**CITY OF ST. HELENS PLANNING DEPARTMENT
STAFF REPORT**

Conditional Use Permit CUP.2.24 & Variances V.8.24 - V.11.24 (four Variances total)

APPLICANT: Dan Hatfield
OWNER: LAGRAND TOWNHOMES LLC

ZONING: General Residential, R5
LOCATION: 5N1W-34CC-09200; NE corner of the Wyeth and N. 5th Streets intersection
PROPOSAL: Build a triplex on formerly developed lot with multiple Variances

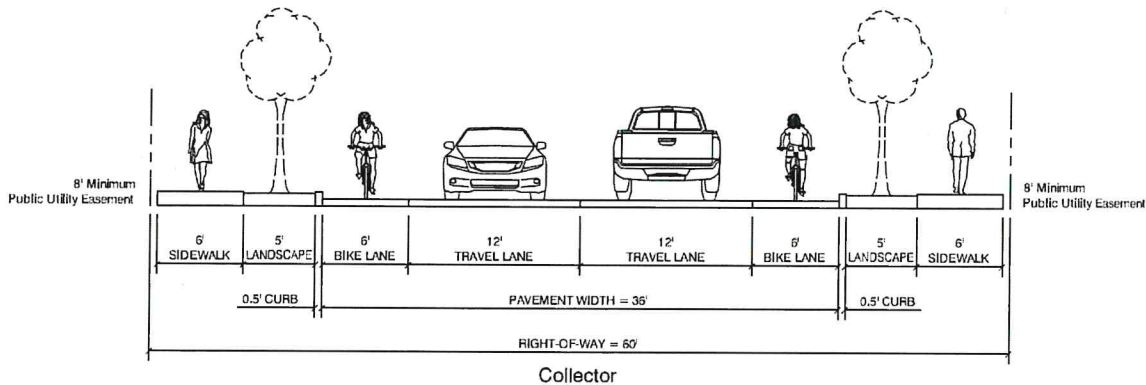
This is not met; **Need Variance:** see V.10.24.

Non-living windowed room areas are along the Wyeth Street side of the building. Provided the existing sidewalk does not move (which is shown incorrectly on the preliminary plans as the sidewalk does not abut the property line), there should be 8' of separation, but maybe not 10 feet. Living room areas are proposed on the opposite side of the building from Wyeth Street.

Because new frontage improvements are possible, that should be examined. The normal cross section shown above has the sidewalk close to the property line. However, it also calls for a 60' wide right-of-way width, and the current width is 80' wide. The improved (asphalt) street is also more-or-less centered in the right-of-way (not skewed to one side). So, it is conceivable the extra right-of-way can accommodate the walkway separation and proposed on-street parking and shall be a condition of approval to ensure design consideration.

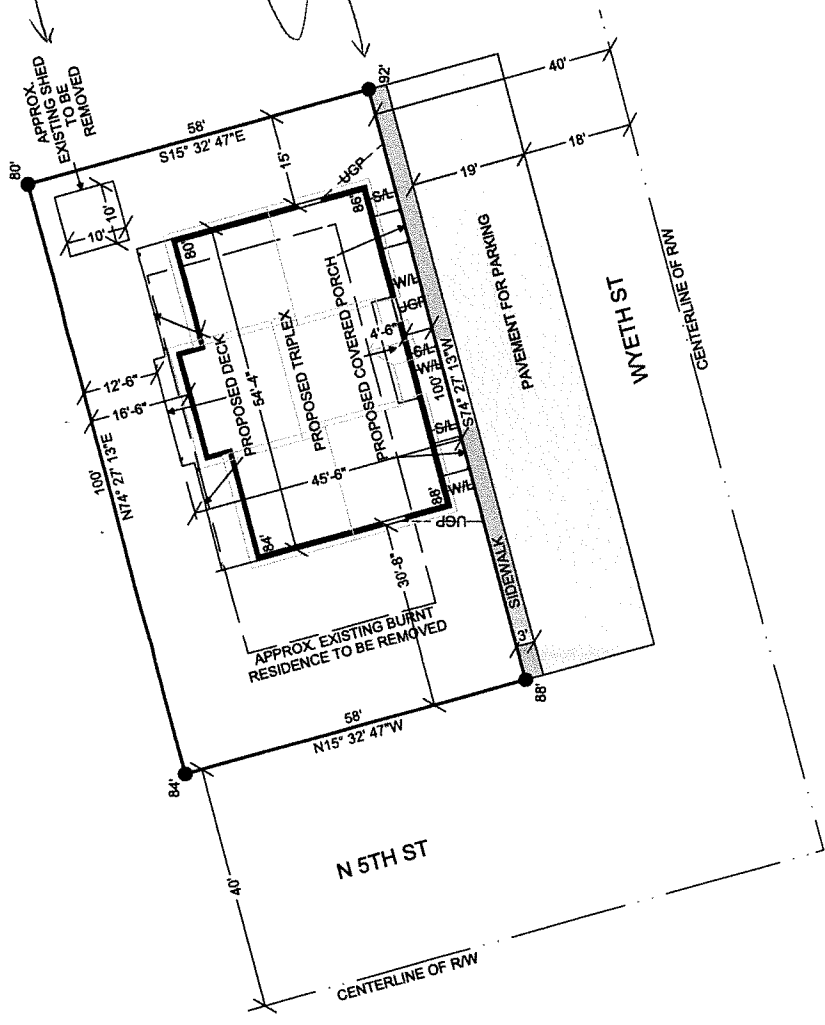
I am not able to put parking on the back or the side of the property. Street is 9 feet higher then the back of the property.

SIDEWALK DOES NOT GOES ABOUT PROPERTY LINE. RATHER MANY FEET SEPARATE THE SIDEWALK FROM PROPERTY LINE

FRONT ELEVATION
SCALE: 1/4" = 1'-0"

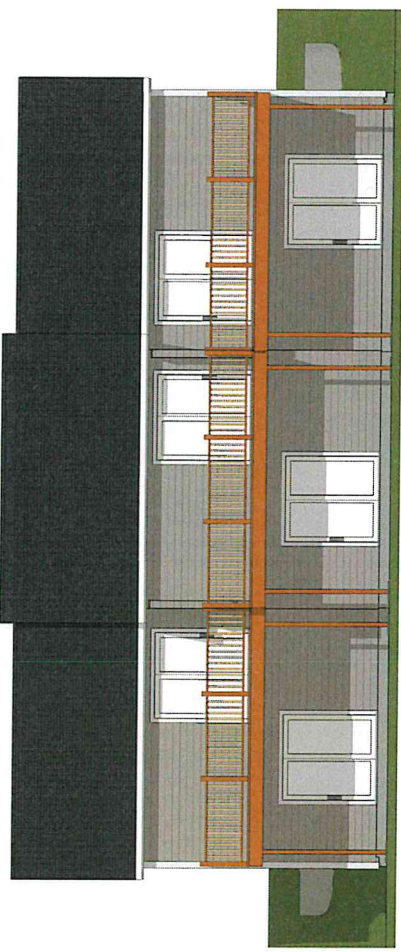
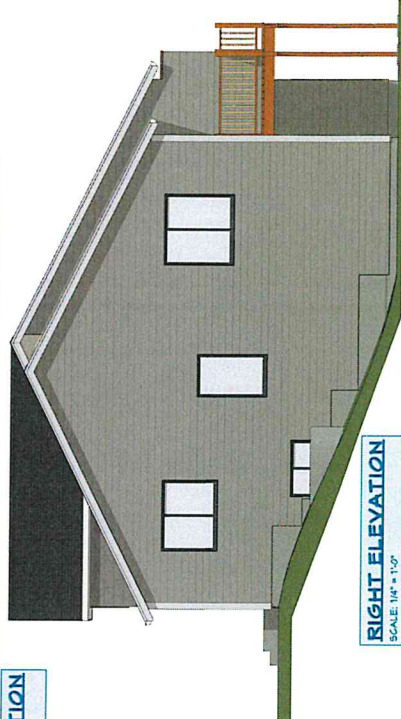
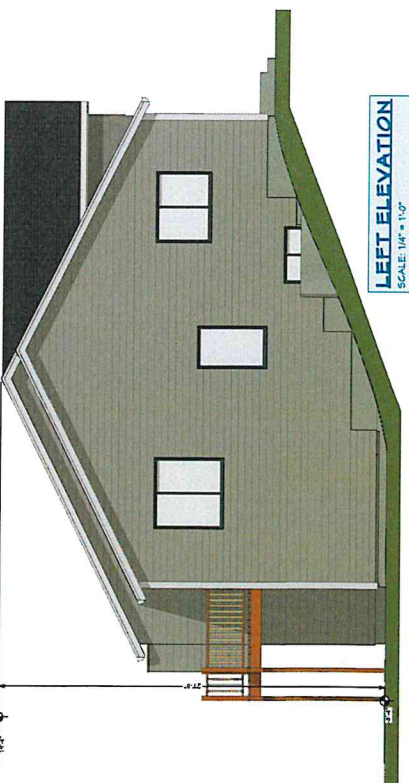
Regarding the exterior multidwelling elevation requirements, the building's length is 55 feet which would require one vertical face offset. In this case, there are more, though the recess and extension are only 4 feet (not the minimum 8 feet) and the break/offset in roof elevation is one foot instead of three feet.
